Crabtree, Rohrbaugh & Associates - Architects

Project : Renos & Additions to Northern
Address: Lebanon Middle & High School

Change Order No: 23
Date: 8/2/2024

ASI #17 Door Hardware

ARCHITECT'S SUPPLEMENTAL INFORMATION – ASI #17

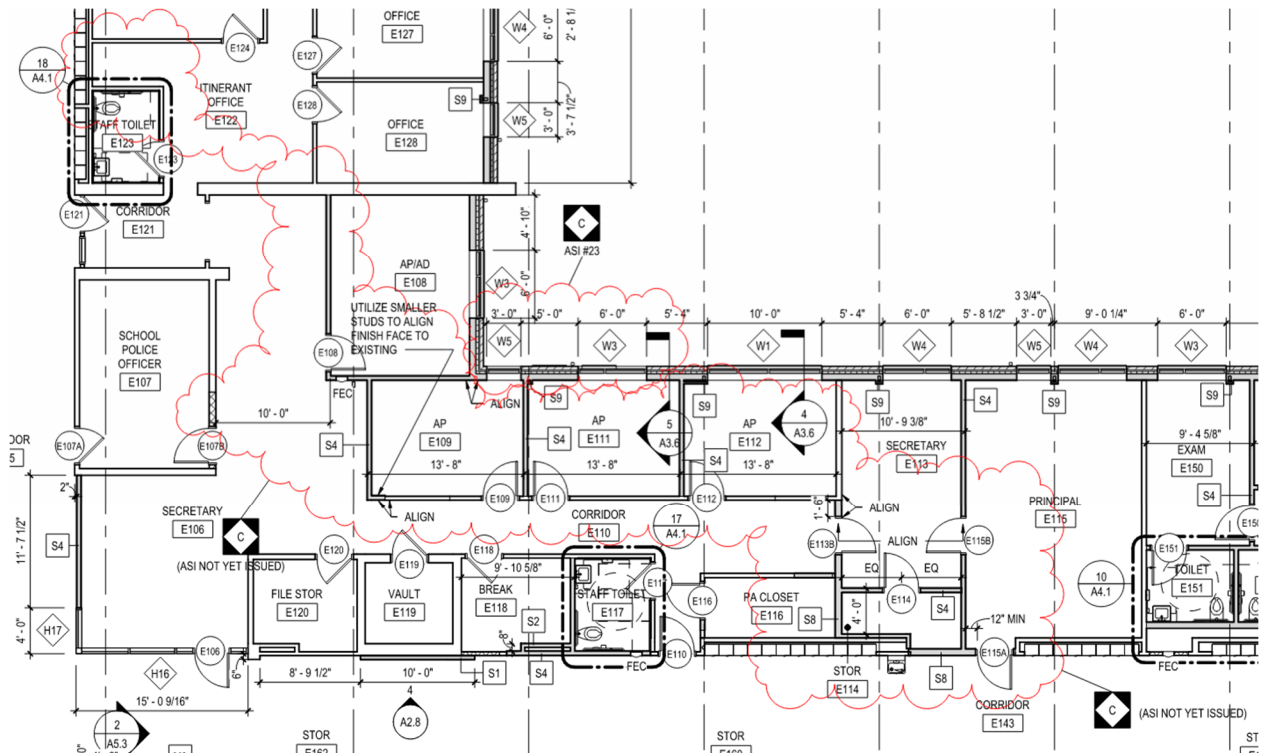
- This ASI contains revisions to door access and door hardware.
- There are also updates to the door schedule to capture mark-ups in returned door/frame shop drawings.
- As a note, the revisions also include doors and frames related to a forthcoming separate ASI. Please include the doors and frames in this ASI, to expedite the door/frame procurement. For context, below is a snip of the forthcoming layout adjustment in a future ASI:
